HISTORIC AND DESIGN REVIEW COMMISSION

Agenda Item No: 34

HDRC CASE NO: 2016-255
ADDRESS: 431 QUEENS CRESCENT
LEGAL DESCRIPTION: NCB 3089 BLK 5 LOT E IRR 120 FT OF 9 & E TRI 1 FT OF S 70 FT OF 10
ZONING: MF33 H
CITY COUNCIL DIST.: 1
DISTRICT: Monte Vista Historic District
APPLICANT: Robert Murray, AIA
OWNER: Pursuant Ventures Development, LLC
TYPE OF WORK: Carport, Driveway, Front Entrance modification, Addition
REQUEST:

**Historic and Design Review Commission
Design Review Committee
Report & Recommendation**

① DEMO FLOOR PLAN
SCALE 1/4" = 1'-0"

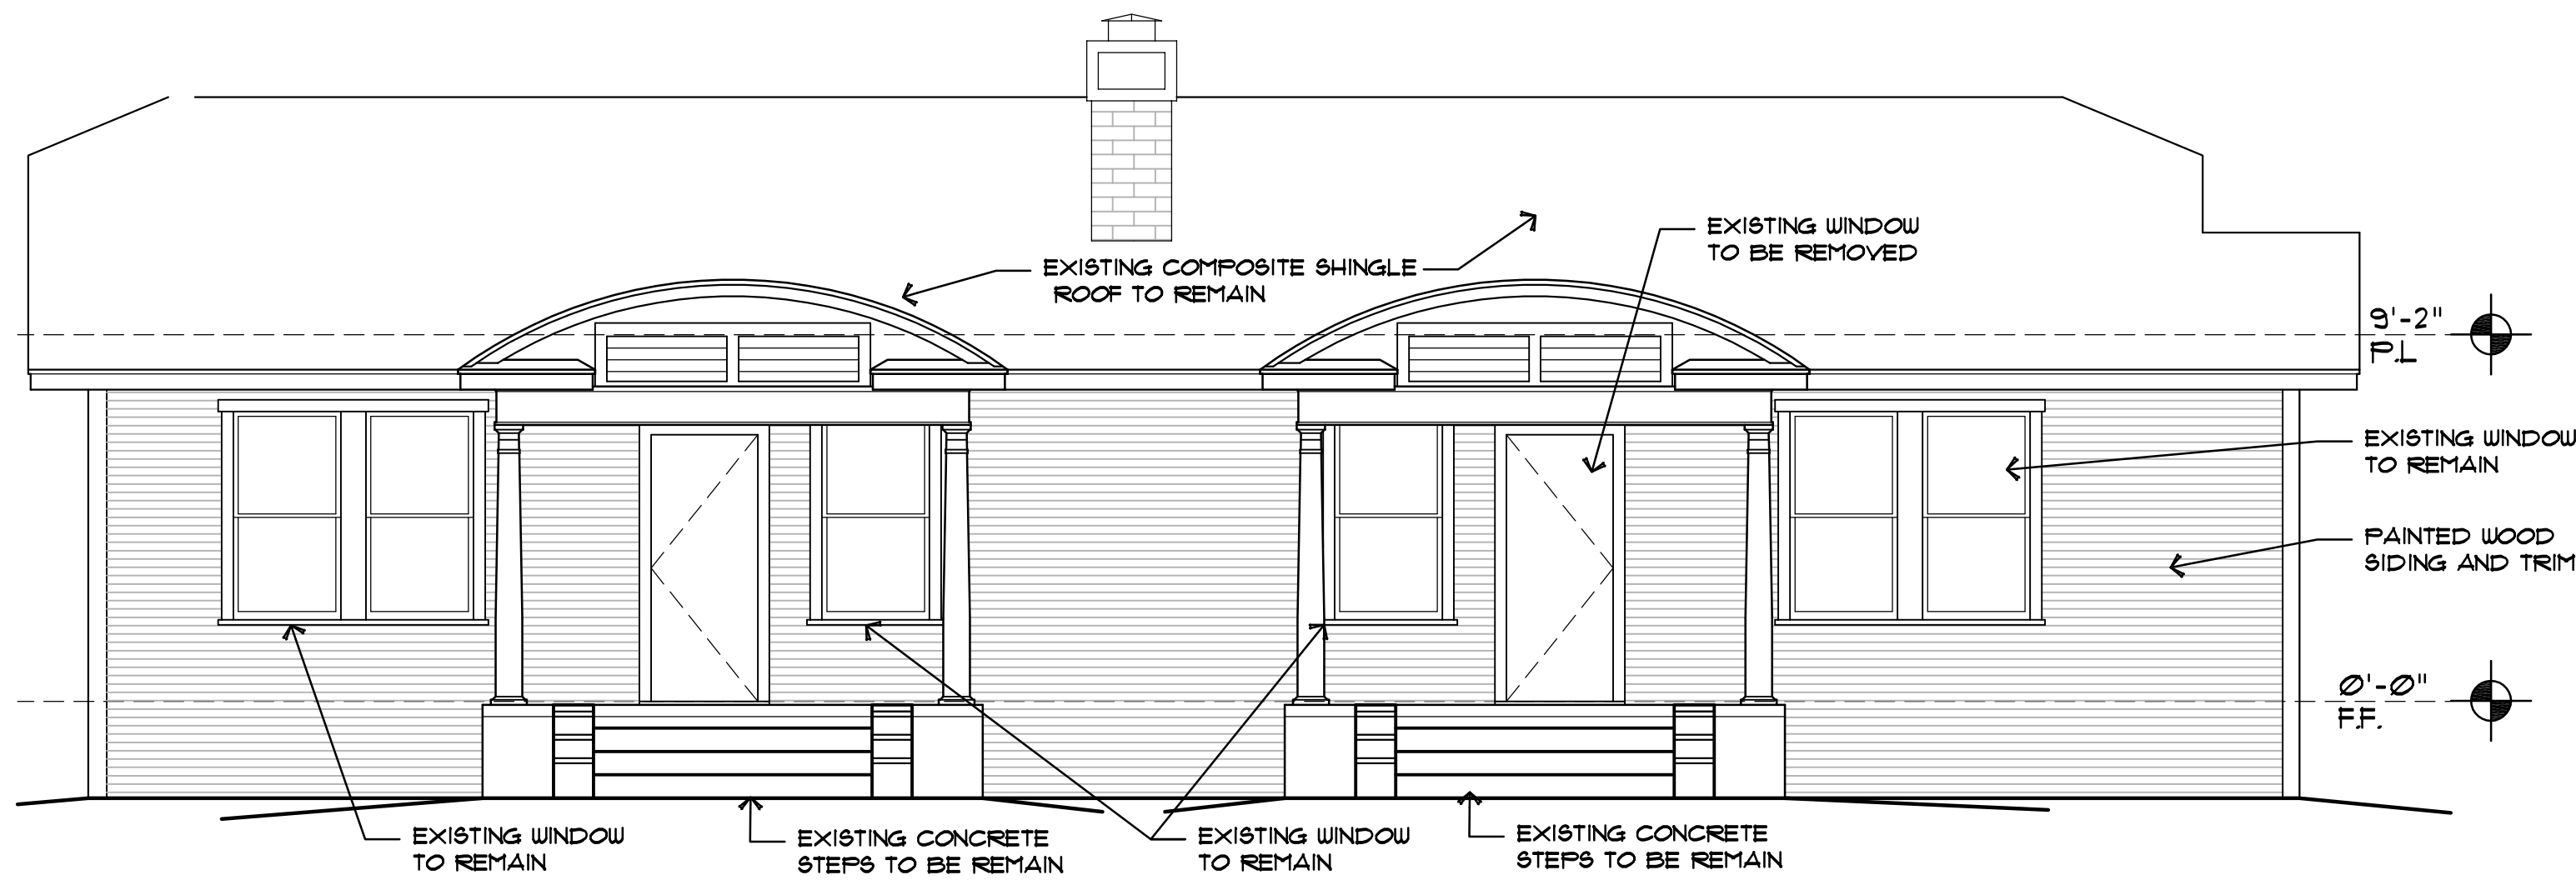
- f. **TRANSITION** - A transition between the primary historic structure and the addition is needed in order to differentiate the addition from the existing structure. The proposed addition is recessed from the corners, creating a distinction between the old and new. Staff finds this floor plan consistent with the Guidelines.

- s. WINDOW OPENINGS - The applicant is proposing to remove two doors and two windows, and alter two windows on the rear elevation, remove one window on the south elevation, and alter 3 window openings on the north elevation. According to the Guidelines for Exterior Maintenance and Alterations 6.B.i, window and door openings should be preserved. Staff finds the removal of the windows where the addition to be located appropriate, but finds the removal of the two door and altering of the window openings not consistent with the Guidelines. Staff recommends that the existing window and door openings be preserved.

Staff recommends denial of item #7 based on finding s.

1 PROPOSED FRONT ELEVATION (EAST)
SCALE 1/4" = 1'-0"

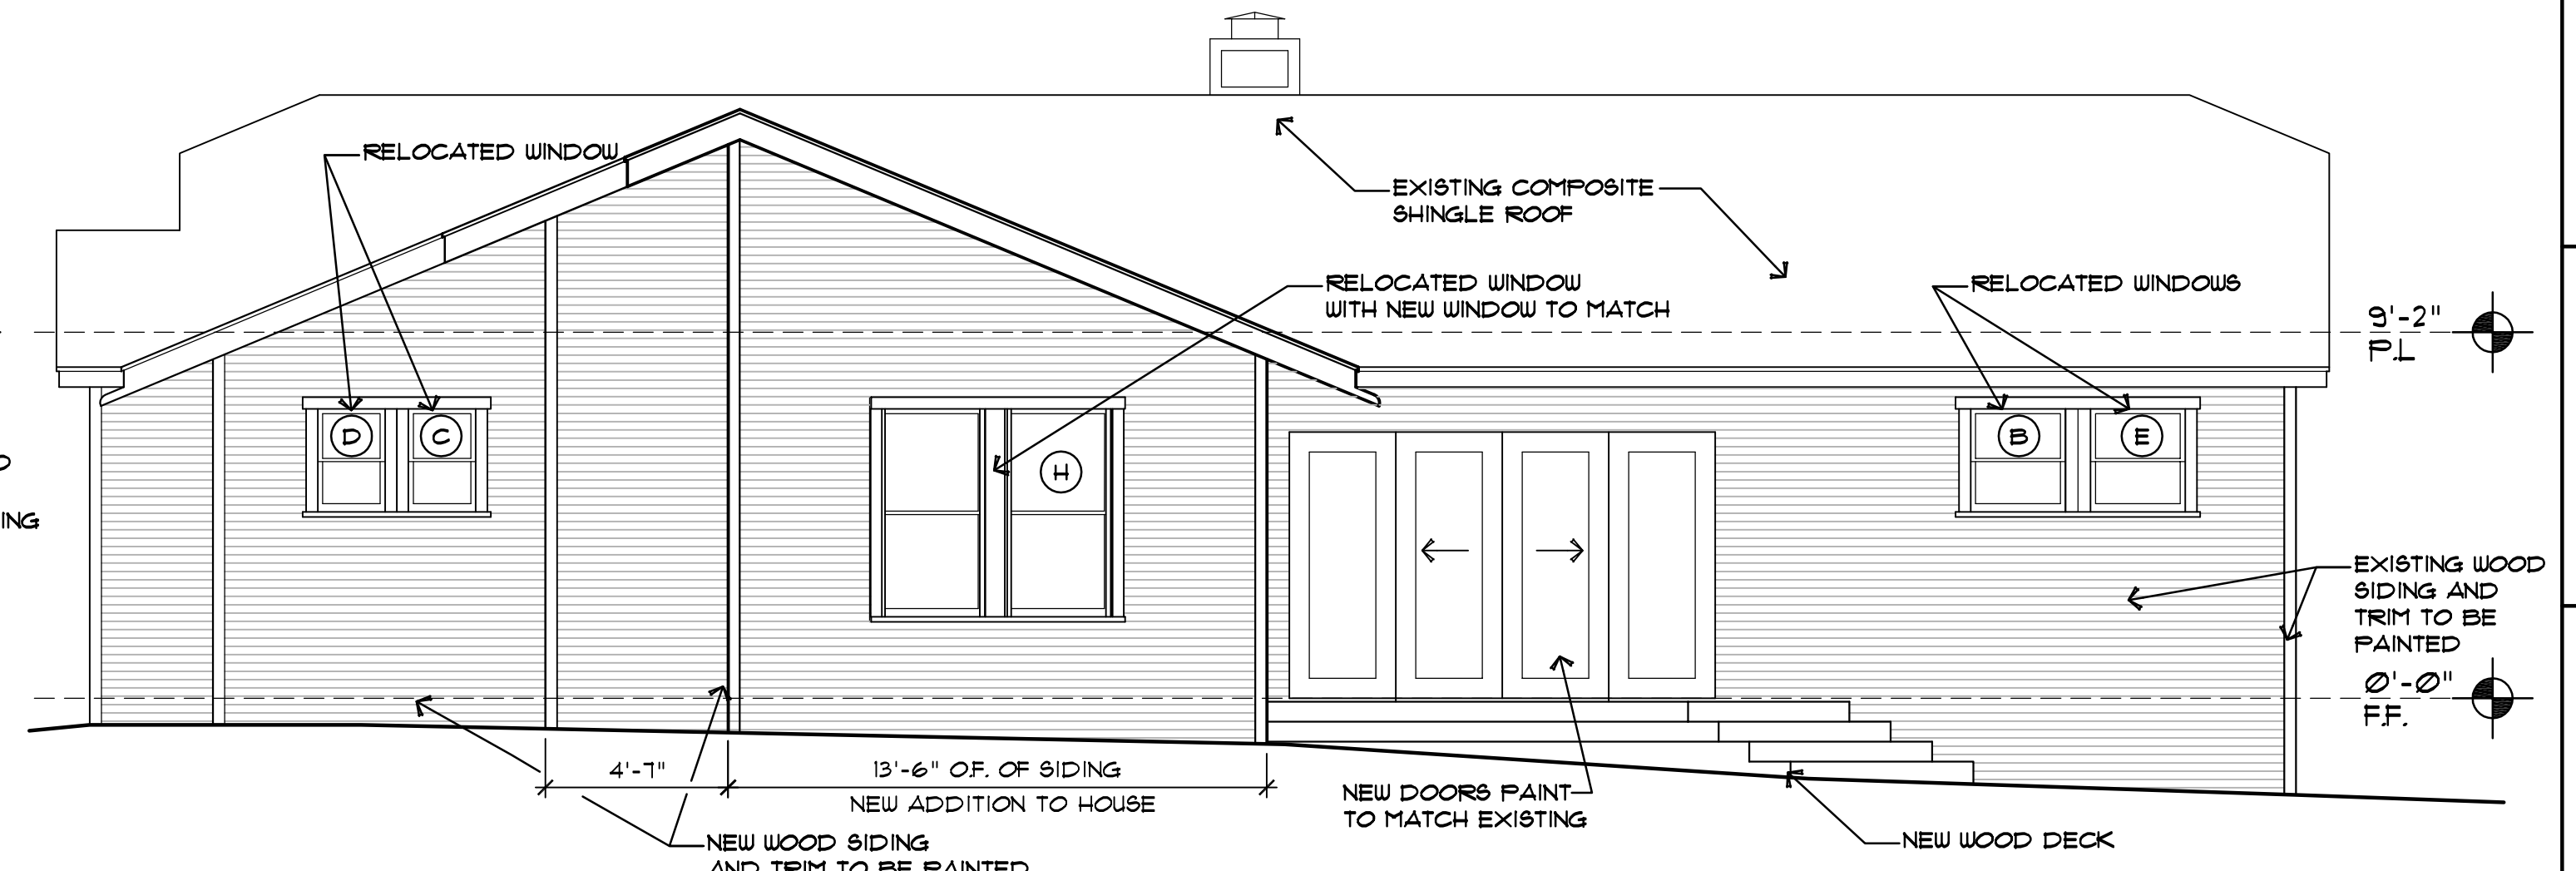
- i. **FRONT PORCH** - Currently, there are two individual concrete front porches with two browed arches, each with two rounded column supports and two front doors. The applicant is proposing to remove the right front door and install a wood one over one window. According to the Guidelines for Exterior Maintenance and Alterations 6.B.i, window and door openings should be preserved. The proposal to alter window openings is not consistent with the Guidelines. Staff recommends that the existing window opening be preserved.

- j. **FRONT PORCH** – Additionally, the applicant is proposing to connect the two existing concrete porches and create one long porch with wood decking, steel and wood trellis connecting the arches, and installing 36” decorative wood railing around the porch. The four round columns will remain and connected with simple railing where needed. According to the Guidelines for Exterior Maintenance and Alteration 7.B., design replacement elements to be simple and to not distract from the historic character of the building. Staff finds the proposed design of the trellis simple and appropriate for the architectural style of the building, therefore is consistent with the Guidelines.

- r. FRONT DOOR – Currently, there are two white solid paneled front doors with door screens. The applicant is proposing to replace both front doors with wooden craftsman styled doors both with three lights. This is consistent with the Guidelines for Exterior Maintenance and Alterations 6, which states non-historic doors should be replaced with doors that would be typical for the architectural style of the building.

- 1. That the front door openings be retained.
- 2. That the dimensions of the ribbon strips be submitted to staff prior to receiving a Certificate of Appropriateness.

2 PROPOSED BACK ELEVATION (WEST)
SCALE 1/4" = 1'-0"

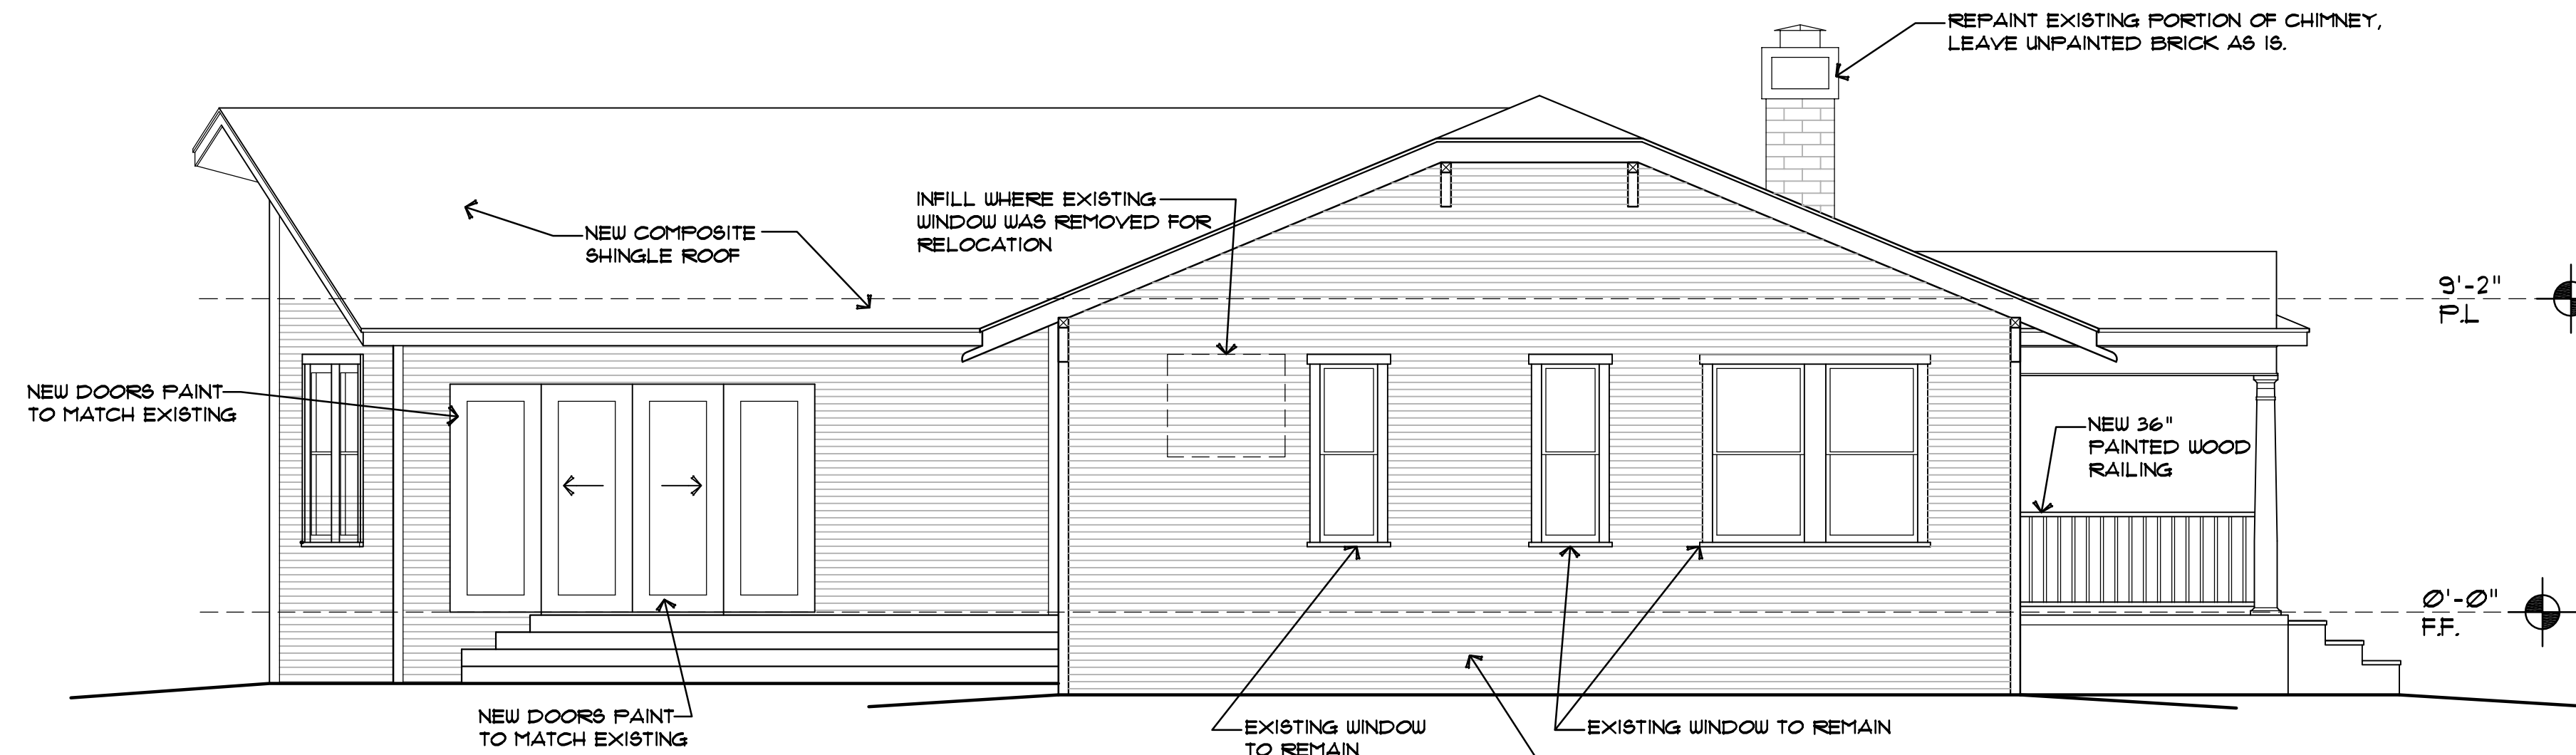
- c. **MASSING/SCALE** - At the rear of the primary historic structure, the applicant is proposing to construct an addition of 259 square feet with wood siding and a gable roof. Guidelines for Additions 1.A. states that additions should be sited to minimize visual impact from the public right of way and be subordinate to the historic structure. Staff finds the construction of the addition to the rear and with a rear facing gable, which matches the roof form of the existing structure, will not impact the public right-of-way.

- d. **ROOF FORM** – Guidelines for Additions recommend additions and feature a roof form comparable to that of the primary historic structure. The existing structure has a side and rear gable, and the proposed roof of the addition adds another rear gable. This is consistent with the Guidelines.

- g. **ARCHITECTURAL DETAILS** – The applicant is proposing to install a double window with two one over one wood windows and a French door with two flanking tall fixed wood windows in the addition and three fixed windows on the left elevation, some of which are relocated, salvaged windows. The windows proposed are of the same size or proportion as existing windows, which are both wood one over one. Staff finds the proposed windows on the addition consistent with the Guidelines for Additions, which state to incorporate architectural details that are in keeping with the architectural style of the original structure.

- h. **DECK** – Currently, there is lawn to the rear of the existing structure. The applicant is proposing to construct a 12’-8” x 14’-4”, including steps, along the rear of the existing house and proposed addition. Staff finds the deck will not be seen from the public right-of-way, subordinate to the historic structure, and will not impact or cause damage to the historic structure.
